Revision: 2	<i>Keith Snook .info</i>	Page Size: A4	<i>iss. 2 R10 value and R16 position</i>
<b>QUAD II Concordant modified ?</b>			
8 Feb 2005	Drawn: K. Snook	Checked:	Page 1 of 1

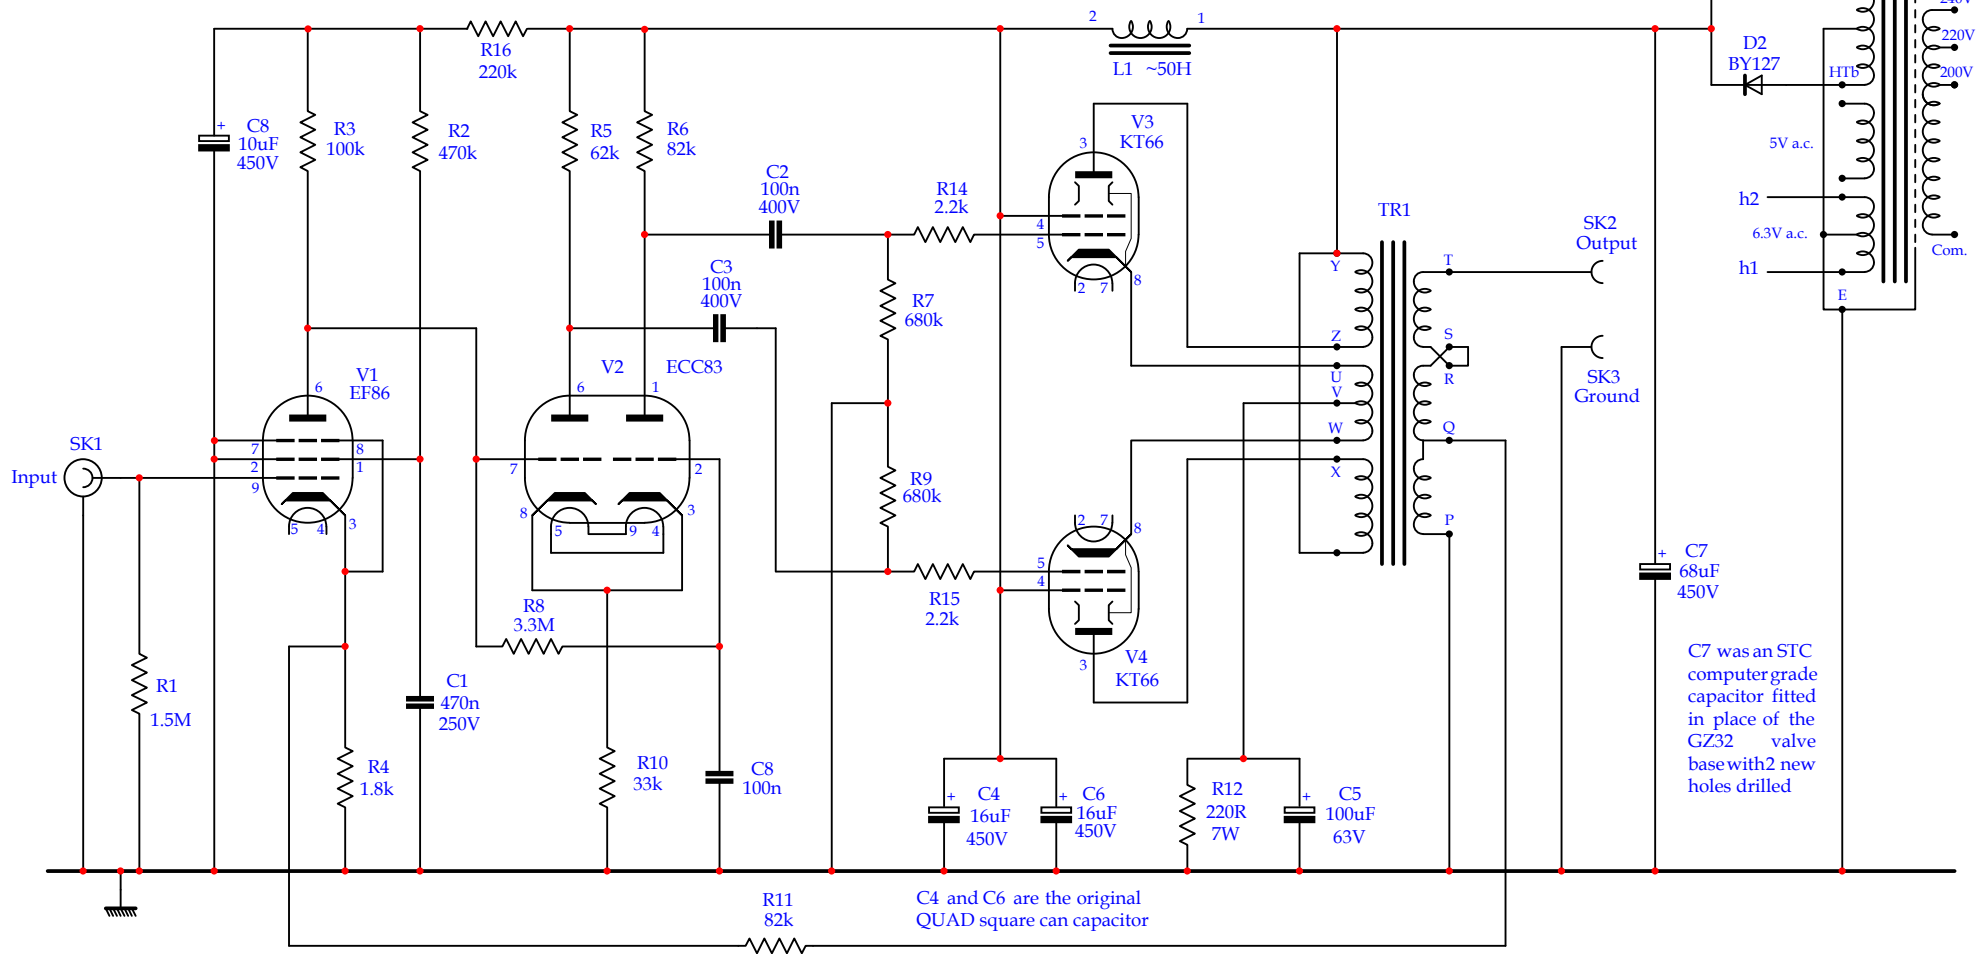
Note: R5 and R6 values are marked as found but are wrong - Both should be the same value ? This appears to be copied - incorrectly - from the LEAK or BBC type phase splitter which is not directly coupled from the previous stage

Note; V3 and V4 are shown as KT66 but valves fitted were the underated 6Y6

C7 was an STC computer grade capacitor fitted in place of the GZ32 valve base with 2 new holes drilled

C4 and C6 are the original QUAD square can capacitor

Note: This schematic is for information only - I DO NOT recommend this is done to any QUAD II
